MEMORANDUM

To: The Design Advisory Board
From: Mary O'Neil, AICP, Principal Planner
RE: ZP21-479, 1-7 Church Street
Date: June 22, 2021

To: The Design Advisory Board
From: Mary O'Neil, AICP, Principal Planner
RE: ZP21-0918CA/CU ZP21-213OG
38 Latham Court
Date: June 22, 2021

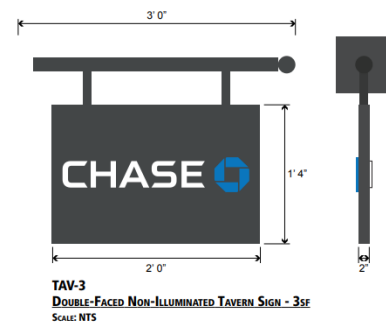
The proposed installation site will center the blade sign on an existing pier; a visually and functionally more appropriate installation location for the blade sign.

SHEET TITLE:
PROPOSED CONDITIONS

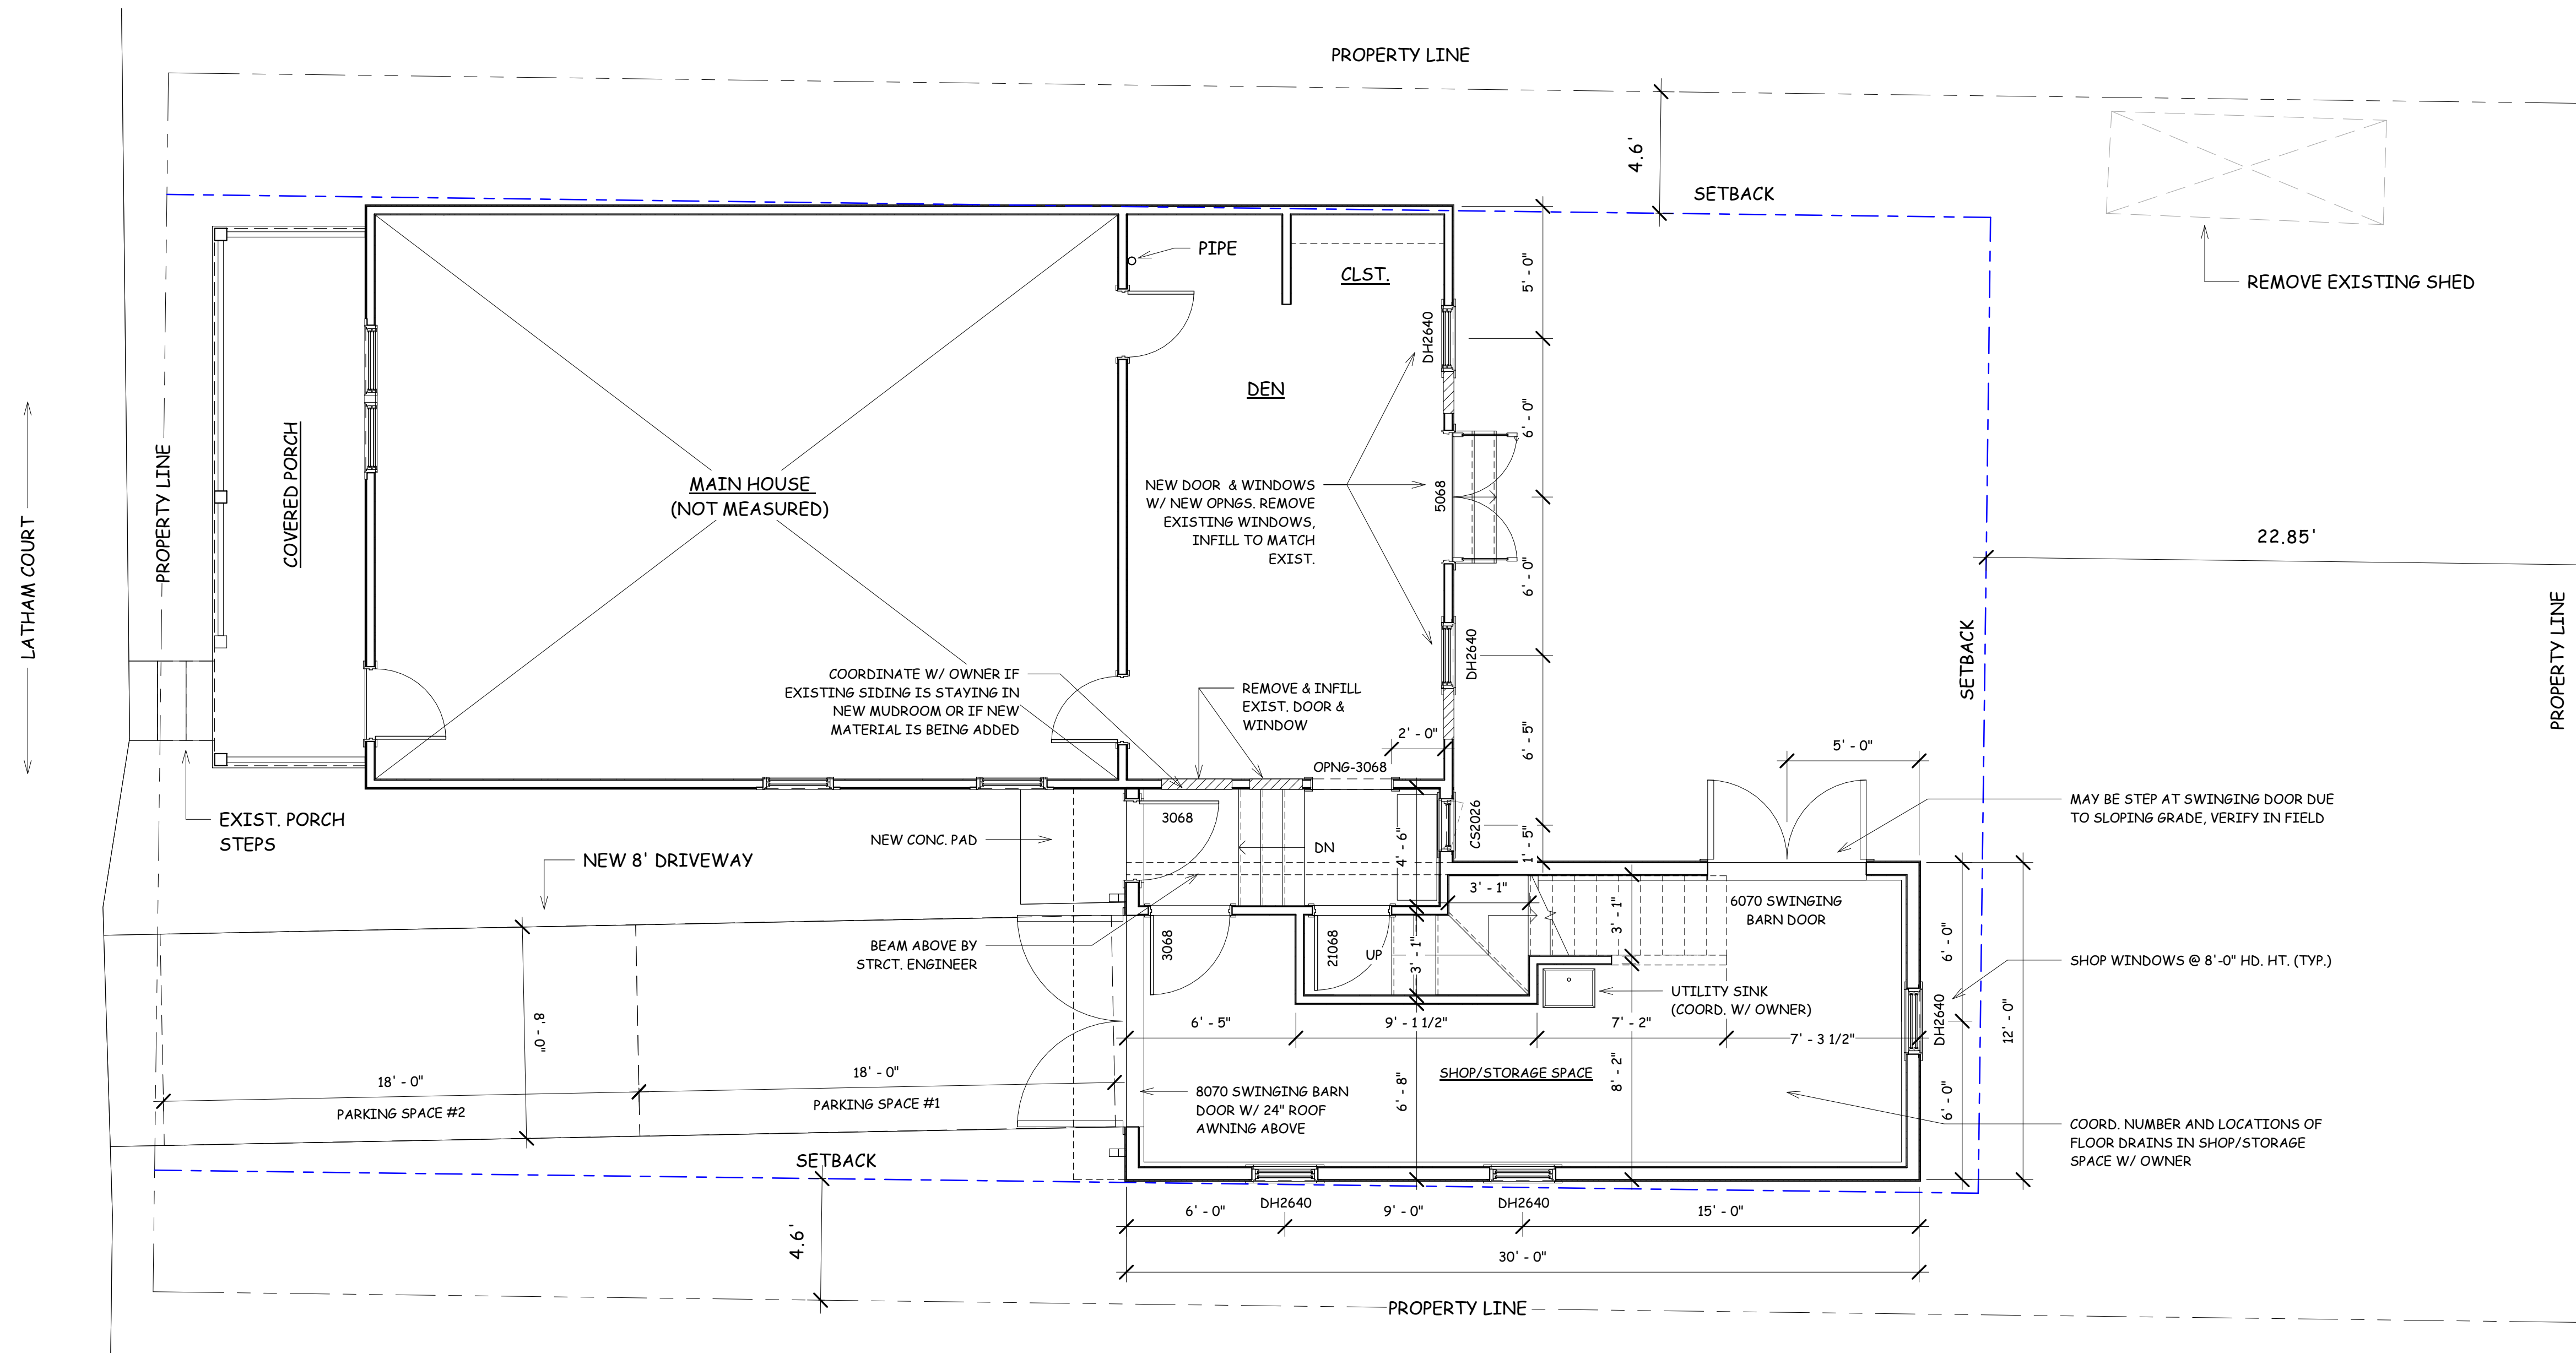
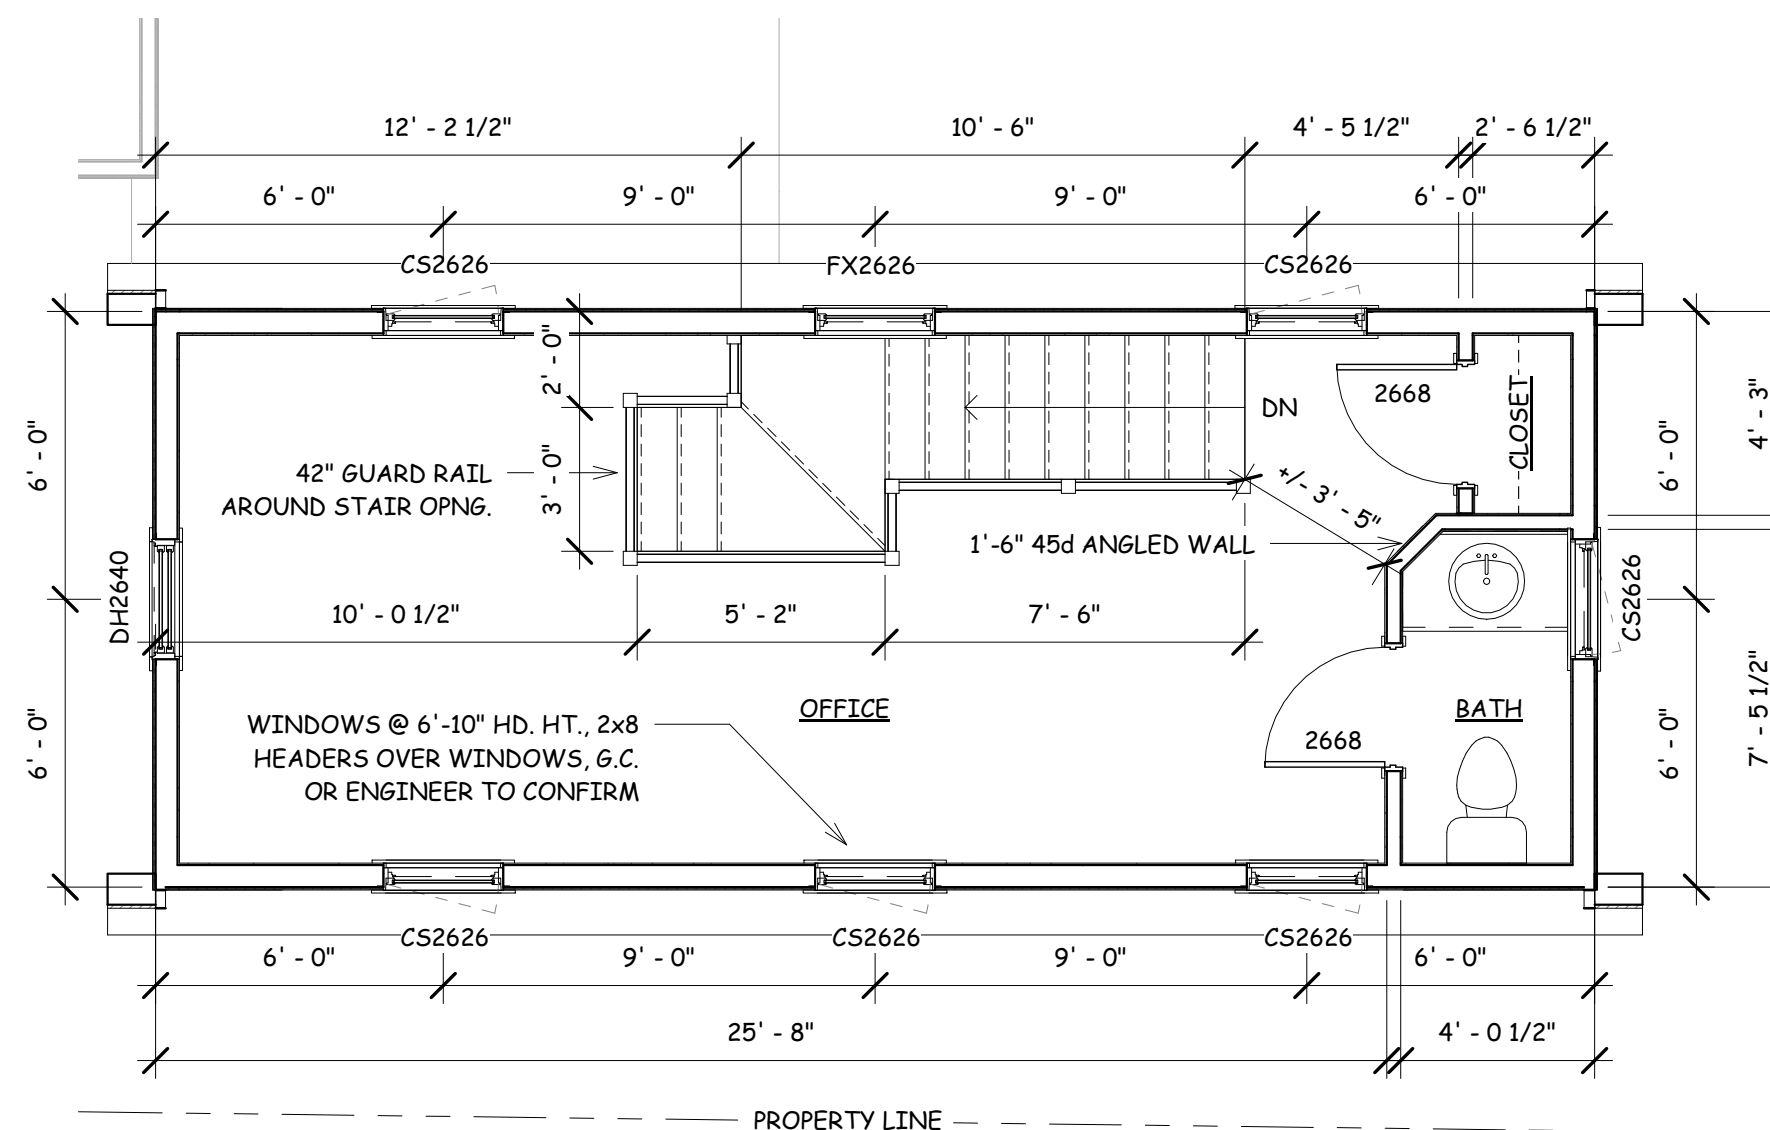
The new entrance to the addition will be under a small pent roof. The newly proposed patio door will be situated under an eaveline, with a modicum of protection from inclement weather.

There is limited room for snow storage north of the driveway unless the garden area may provide such space. South of the driveway has approximately 4'7" that could accommodate snow storage needs.

- A landscaping and tree removal plan will be required (as appropriate) for DRB review.
- Lighting information, including fixture specs, illumination levels and intended location are needed.
- Meters, utility connections, and any mechanical equipment must be illustrated on building elevations or site plan as appropriate.
- The garage door must operate differently to accommodate the two on-site required parking spaces.
- Confirmation is needed for intended fenestration pattern.
- The time frame between building demolition and new construction shall not exceed 6 months.
- No change in use is included within this proposal
- All building materials shall be disposed of in a safe and legal manner.
- Standard Permit Conditions 1-15.

SHEET TITLE:
PROPOSED
ELEVATIONS

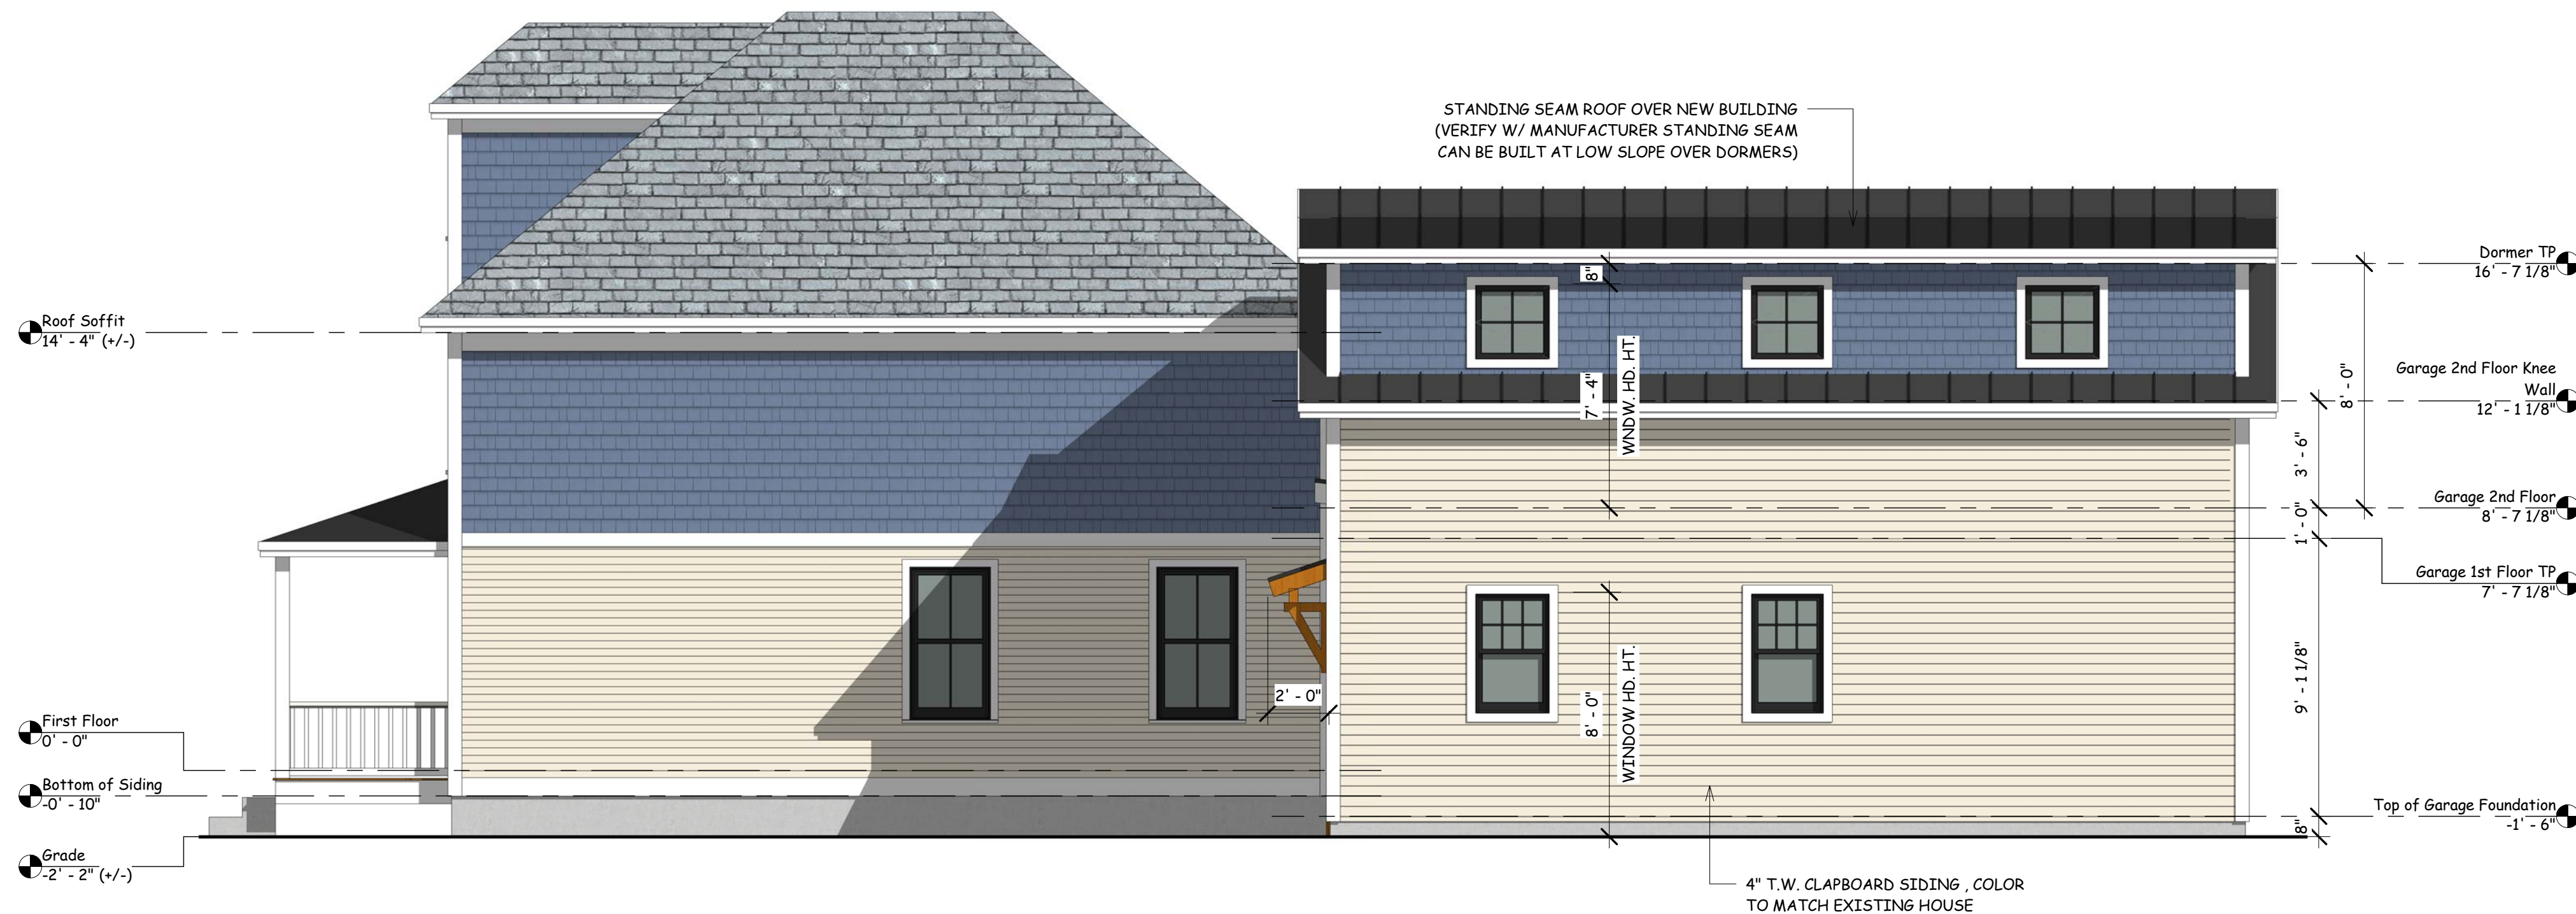
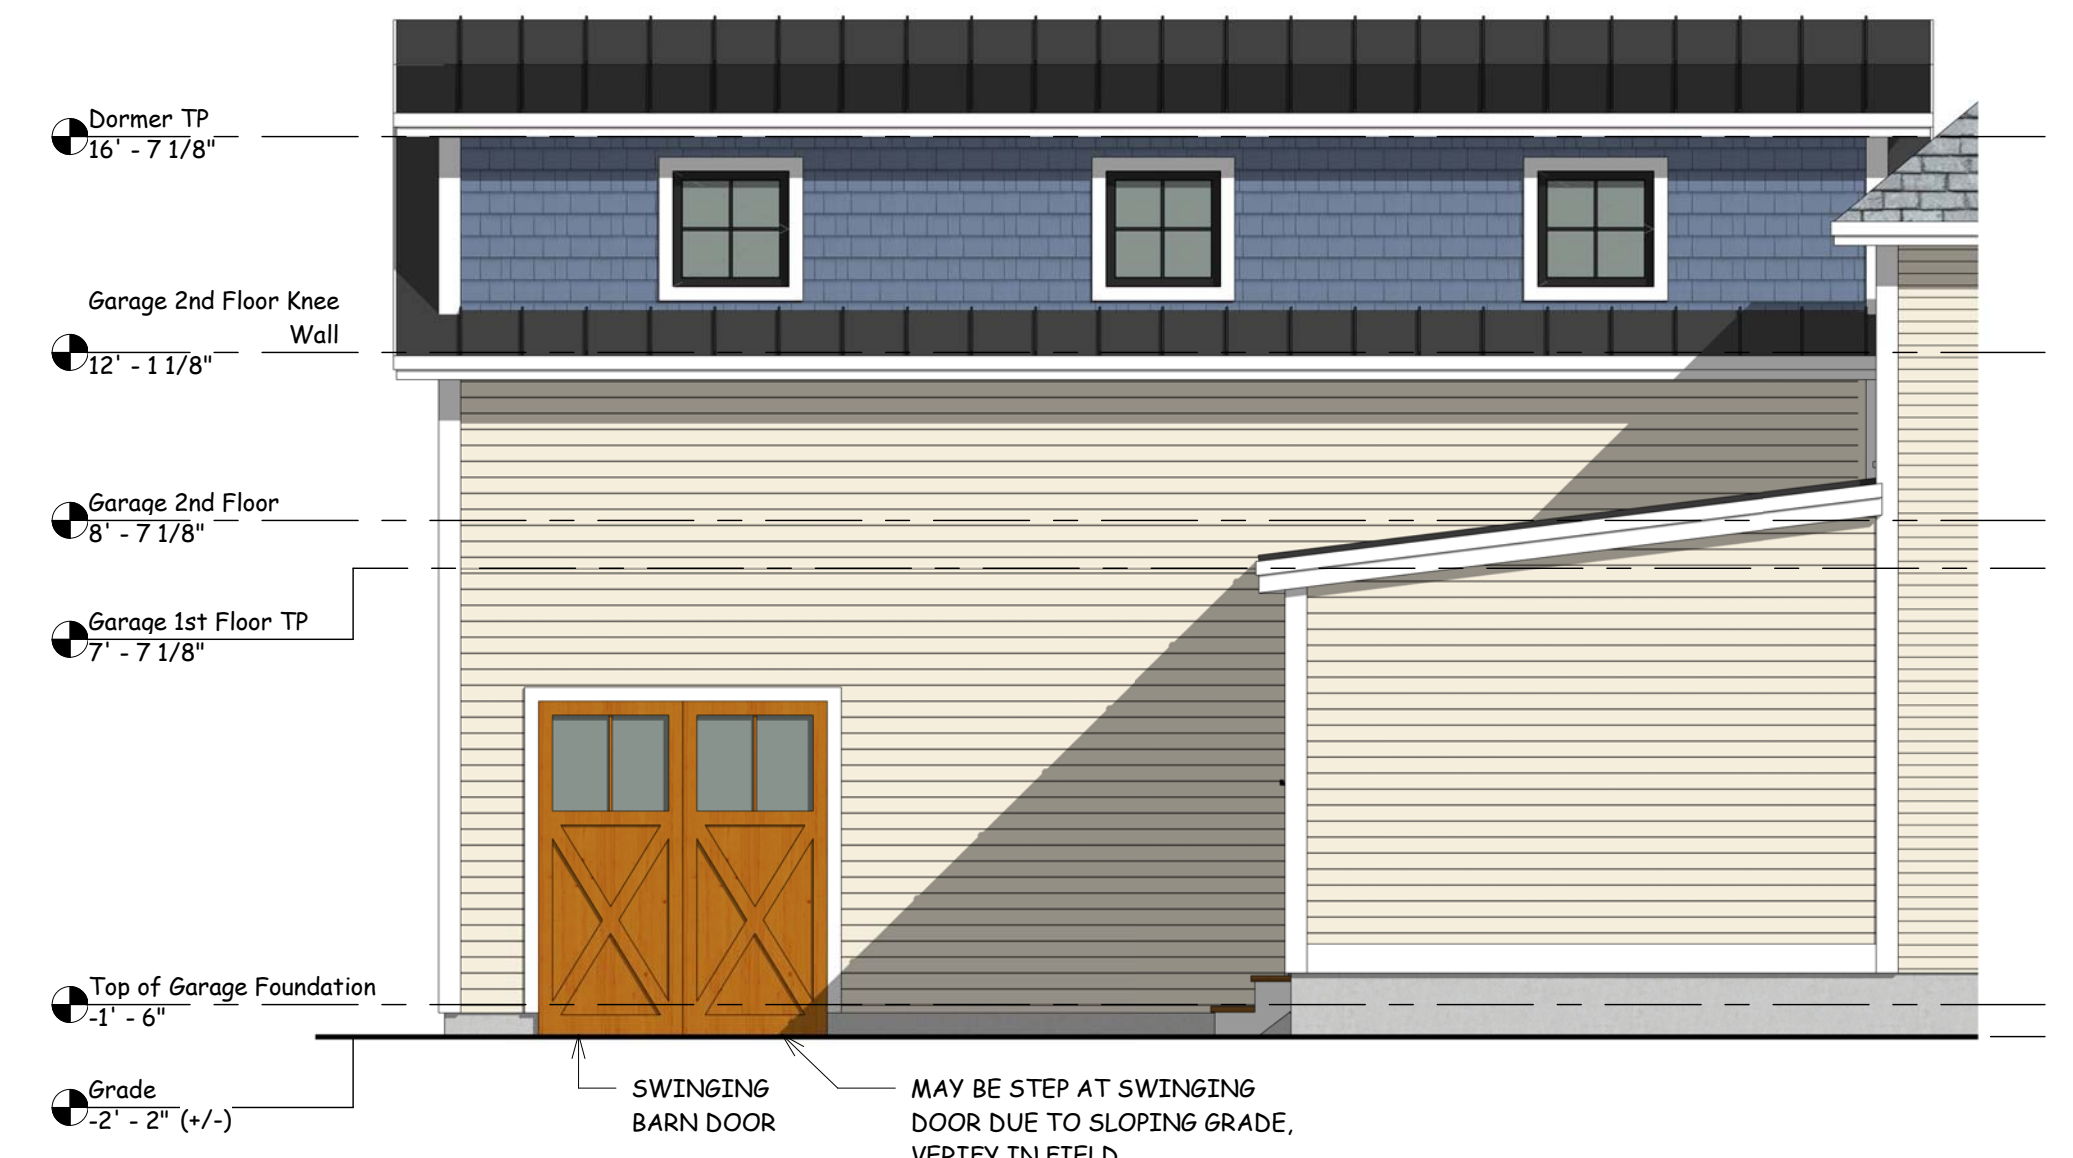
structure and the addition of a French door are included. See plan A-2.

The new addition is proposed to replace the c. 1925 garage. It will be differentiated from the historic home. The DAB must assess the compatibility in materials, features, size, scale, proportion and massing.

Motion by Ron Wanamaker: I move we table the application and ask the applicant to come back with a revised design that is both distinct from and sympathetic to the existing design.
